Re: Response to 1st Conceptual Plan Review
Woodland Heights Road
ARM Project 25011431

**PRELIMINARY ROADWAY CONCEPT PLAN
PROFILES**

WOODLAND HEIGHTS ROAD
IMPROVEMENT
TOWN OF WARSAW

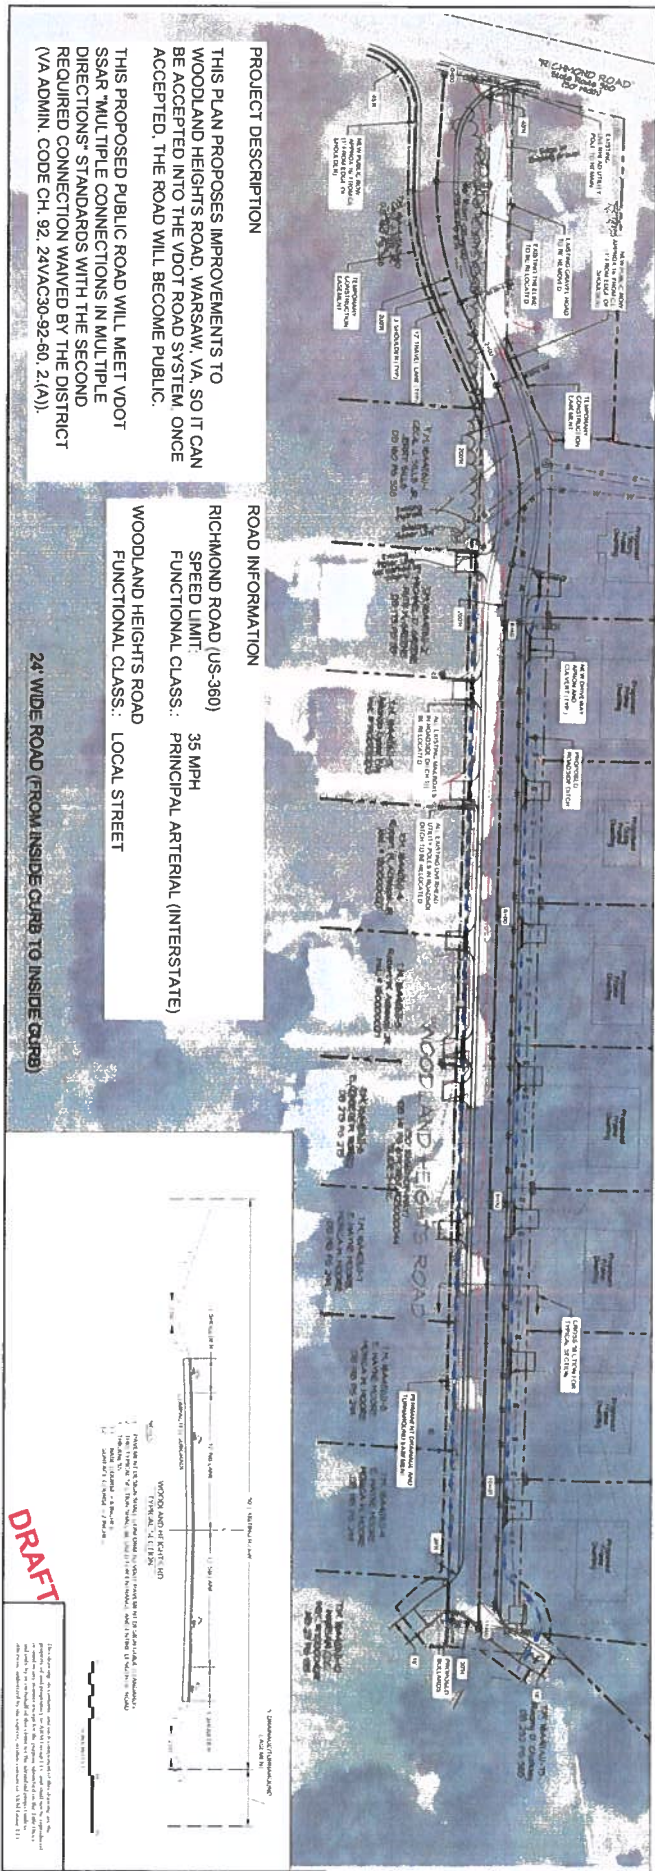
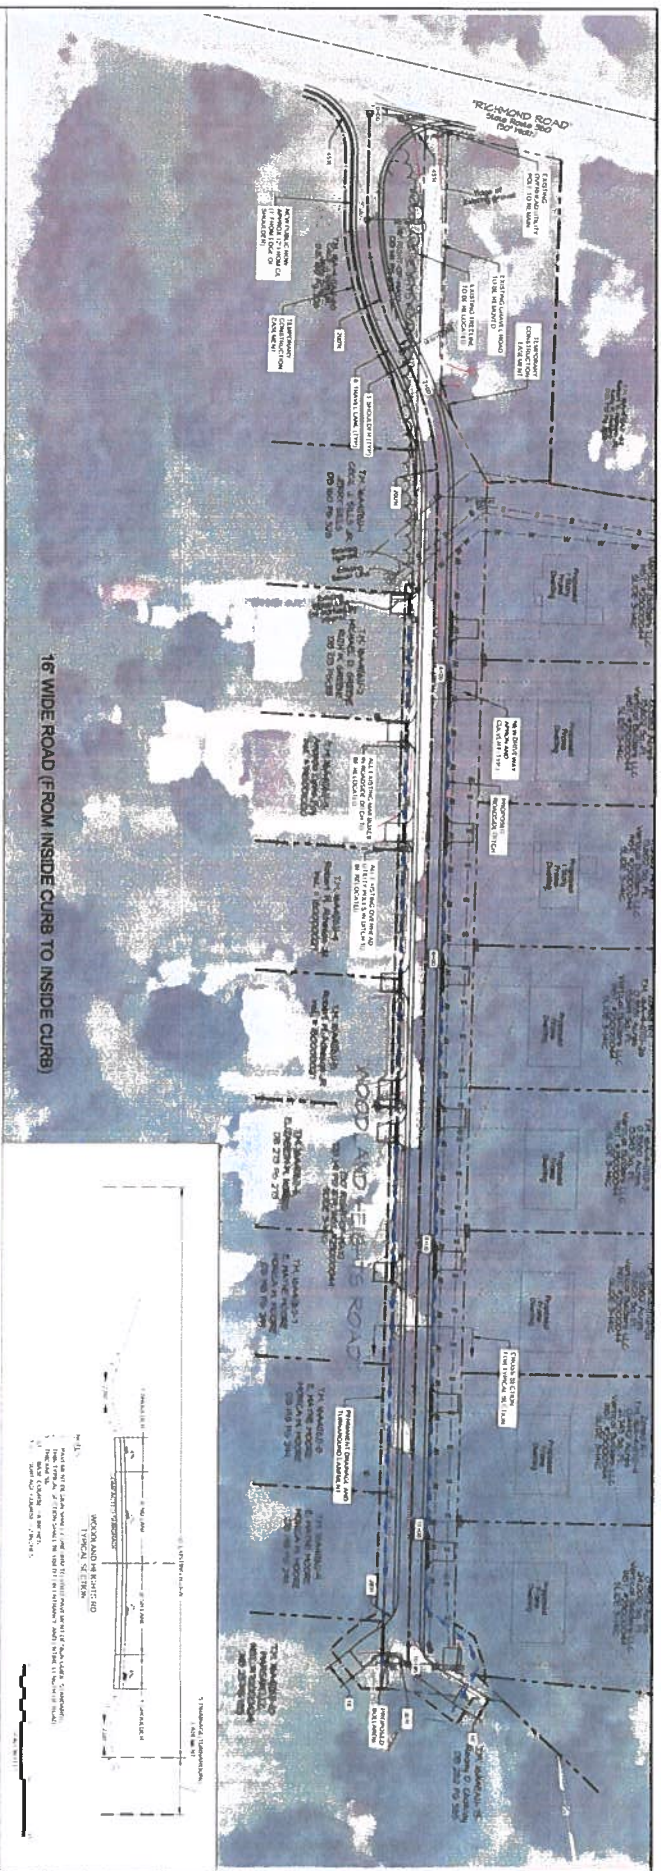
1. The road will need to identify if the street will be private or proposed as public right-of-way for future VDOT maintenance.

2. If the road is proposed as public, then the VDOT SSAR’s shall apply including multiple connections in multiple directions.

6. Road horizontal radii (min. 200'), vertical grade, pavement width, shoulder, drainage, right-of-way, and easements shall be per the RDM Appendix B(1) for public roads.

7. Intersection radii shall be per RDM Appendix F, Table 4-3 and turn around designs shall be in accordance with RDM Appendix B(1).

8. Pavement design thickness shall be in accordance with RDM Appendix F for the entrance and the current version of the VDOT Pavement Design Guide for the remainder of the street.

Response: The proposed right-of-way on the Concept Plan has been revised to be labeled as “public”, and a note has been added to the Concept Plan stating the road is proposed as public.

Response: The road is proposed as public, and a note regarding VDOT SSAR multiple connections standards has been added to the Concept Plan. The proposed public road will require a waiver for the second required connection abiding by VA ADMIN. CODE CH. 92, 24VAC30-92-60, 2.(A):

Response: *The Concept Plan has been revised to conform to the above-mentioned design parameters.*

- *Road horizontal radii is min. 200'*
- *Vertical grade is per 2018 AASHTO Green Book Chapter 5 (Section 5.3)*
- *Pavement width is min. 24'*
 - *Pavement width min. 16' is shown per discussion with the District*
- *Shoulder width is min. 3'*
- *Drainage includes 2% road cross-slope, roadside ditches, and driveway culverts*
- *Right-of-way is min. 30' and min. 1' beyond edge of road components*
- *Easements have been added to encompass roadside drainage beyond the ROW and to encompass the turnaround beyond the ROW.*

Response: *The intersection radii of the Concept Plan have been revised to be 45'.*

Response: *The entrance design thickness shall match the thickness of Richmond Road per Appendix F standards for commercial entrances, and the remainder of the road shall be 6" base course and 2" surface course per VDOT Pavement Design Guide.*
